Access Compliance Report

Public Rights-of-Way

(Curb Ramps)

Intersection ID: 11457	Main Street: TRYON-CHURCH CONNECTOR ST	Cross Street: N_CHURCH_ST	Location: NW
ADA ID: D5555C3A1F04	Ramp Type: ParaDiag	Initial Pass/Fail: Pass	Overall Compliance: No
Severity Score: 0.25			
Codes/Mitigation Info/Possible Solution		Field Measurements/Component Compliance

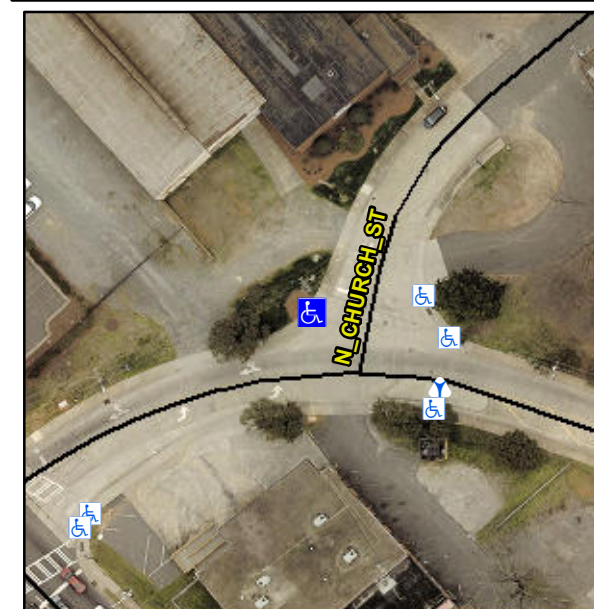
RT RP < 5%

R304.5.3

Compliance	Description	Data	Compliance	Description	Data
N/A	Ramp Length LT (in)	88.0	N/A	Ramp Length RT (in)	63.0
Yes	Ramp Width LT (in)	60.0	Yes	Ramp Width RT (in)	60.0
Yes	Ramp Slope LT (%)	6.7	Yes	Ramp Slope RT (%)	2.5
No	Ramp XSlope LT (%)	3.1	Yes	Ramp XSlope RT (%)	1.0
Yes	Landing Length (in)	60.0	Yes	DWS Provided?	Yes
Yes	Landing Width (in)	48.0	Yes	DWS Contrast?	Yes
Yes	Landing Slope (%)	1.5	Yes	DWS Length (in)	24.0
No	Landing X Slope (%)	2.3	Yes	DWS Full Width?	Yes
N/A	Landing Curb? (Y/N)	No	Yes	DWS Offset (in)	0.0
N/A	Shared Landing?	No			
Yes	Gutter Ponding?	No	Yes	Gutter Slope (%)	4.9
Yes	Gutter Lip Ht (in)	0.0	Yes	Gutter X Slope (%)	1.8
N/A	Painted X Walk1?	No	N/A	Painted X Walk2?	No
	X Walk 1 Direction	To S		X Walk 2 Direction	To E
N/A	X Walk 1 Width (in)	N/A	N/A	X Walk 2 Width (in)	N/A
	X Walk 1 Slope (%)	1.0		X Walk 2 Slope (%)	0.2
	X Walk 1 X Slope (%)	2.2		X Walk 2 X Slope (%)	2.4
N/A	Ramp inside XWalk1?	N/A	N/A	Ramp inside XWalk2?	N/A

Remove & Replace Curb Ramp With Two New Directional Ramps or Equivalent.
